Shotover Country – Special Housing Area Comments on ORC Letter relating to Natural Hazards

Shotover Country Plan Change 41

Peer Review: Supplementary Hydraulic Modelling

Shotover Country Plan Change 41 Expert Caucusing

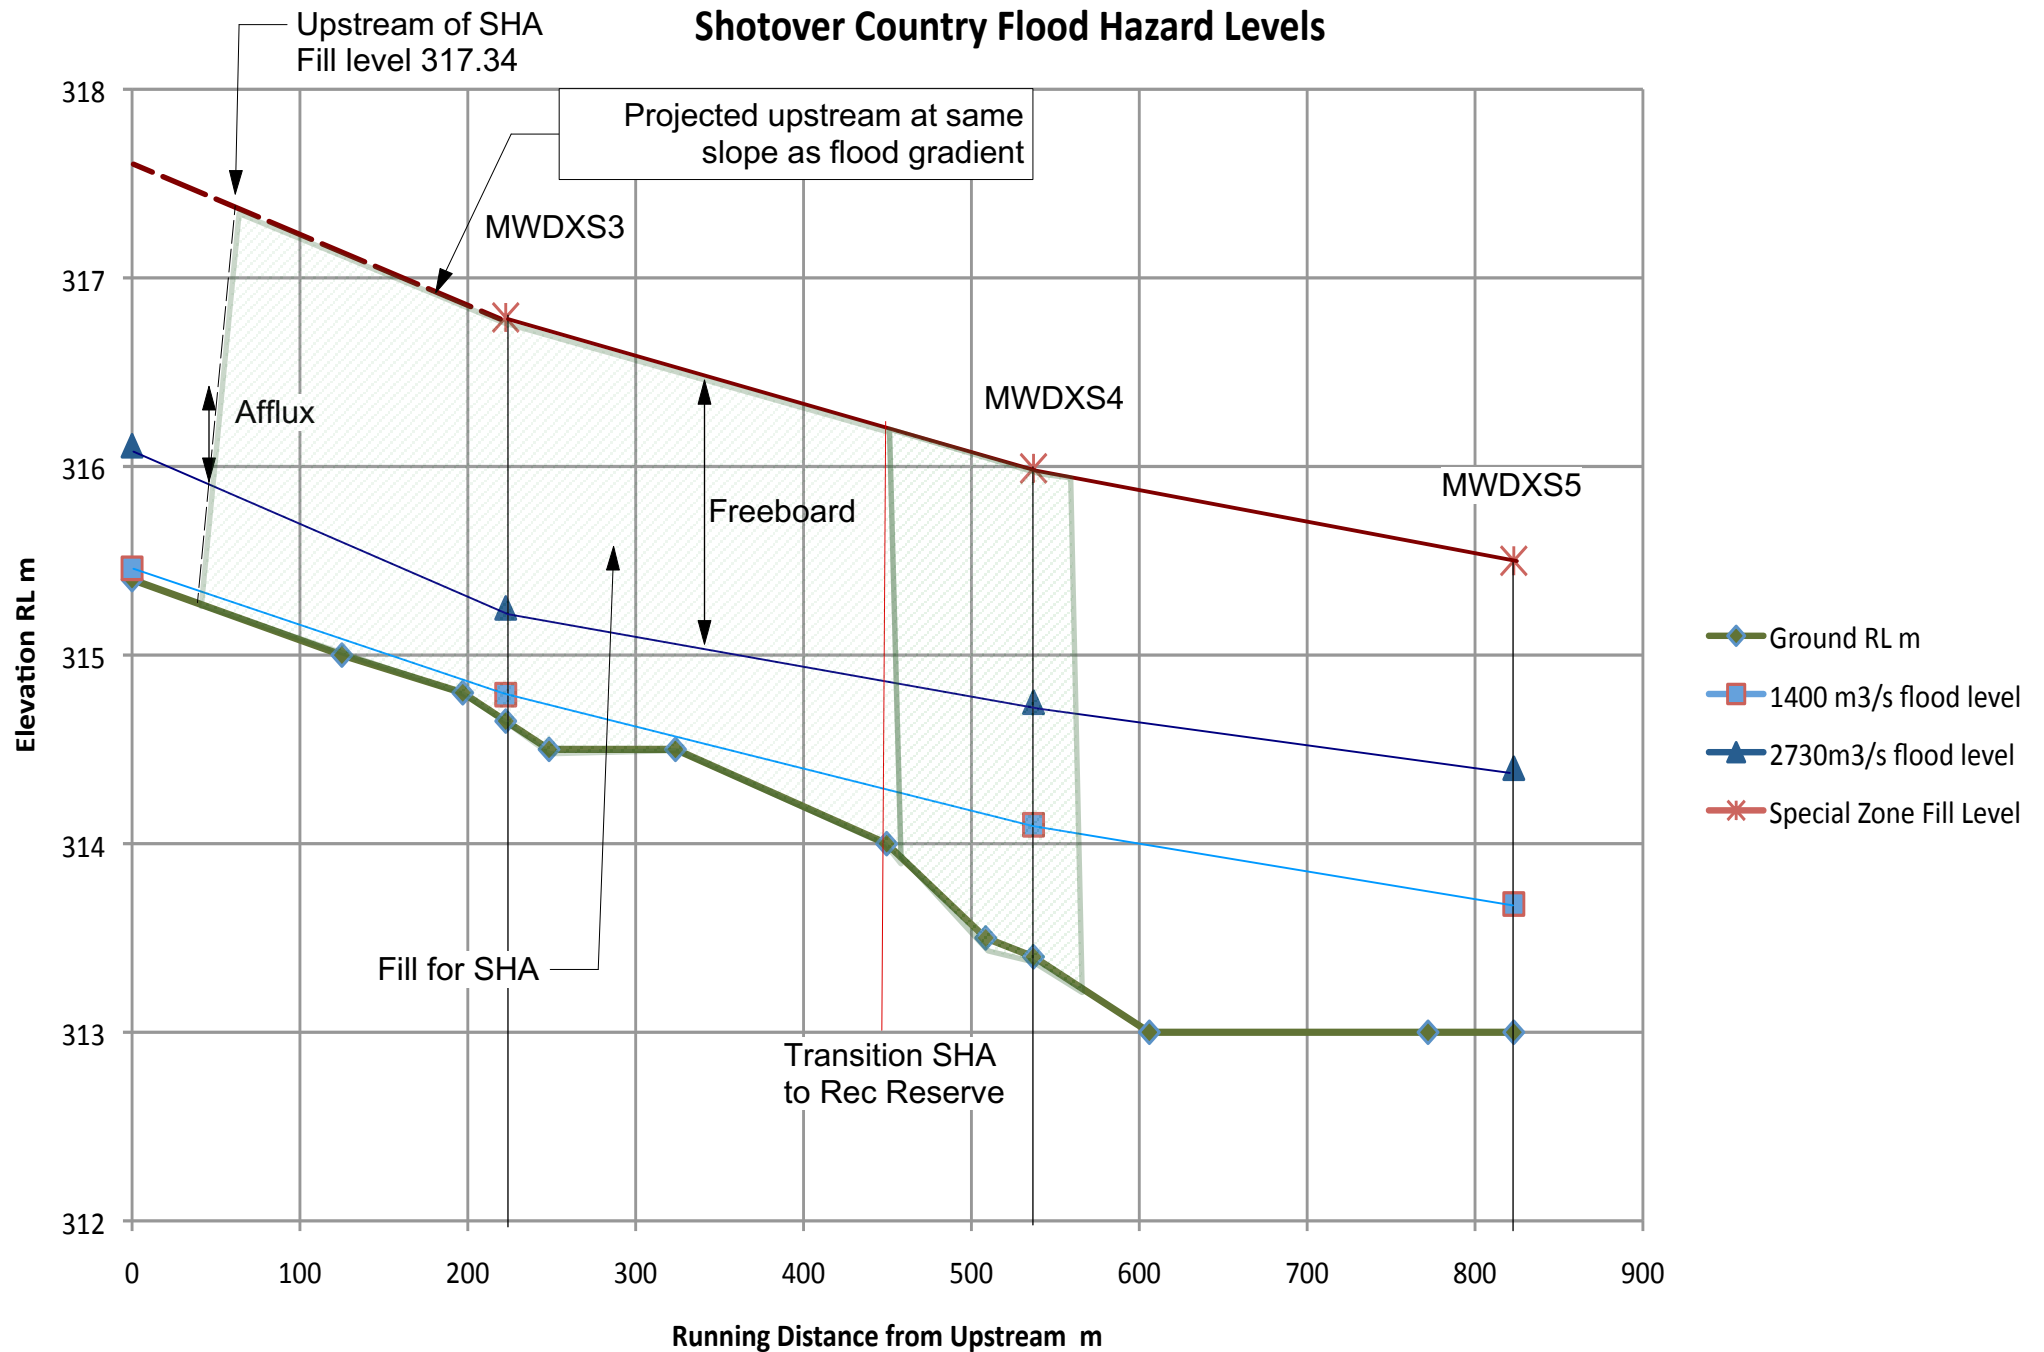
The supplementary modelling undertaken by David Hamilton and Associates has provided very useful data to understand better the significance and adequacy of the freeboard of the proposed Ladies Mile Partnership development. In this respect, the uncertainty related to the estimation of the design flood, the parameters adopted for modelling flood levels, and possible flood waves released from debris dams in the upper catchment has been clarified.

The supplementary modelling results show that:

- For all scenarios identified in the original T&T brief, the minimum freeboard exceeds 800 mm.
- For high climate change impacts to 2090, projected 2110 bed levels in the delta, and 97.5 % confidence limit on the estimation of flood flows, the minimum freeboard to the proposed development, based on the DHA modelling results, would be 0.89 m

- For a debris dam beach-associated flow the proposed development will be 0.1 m higher than the flood levels associated with a flow approximately three times the estimated 100 year peak flow from the catchment
- For a dam breach flow to adversely affect the proposed LMP development, a very large debris dam, with a height in excess of 50m, would likely be required. T&T believes that such an event can be considered to be rare. Nonetheless, should such an event occur the time required to fill the reservoir behind a large debris dam should be sufficient to enable evacuation or other contingency plans to be enacted to manage the risk to downstream property owners and the wider community.
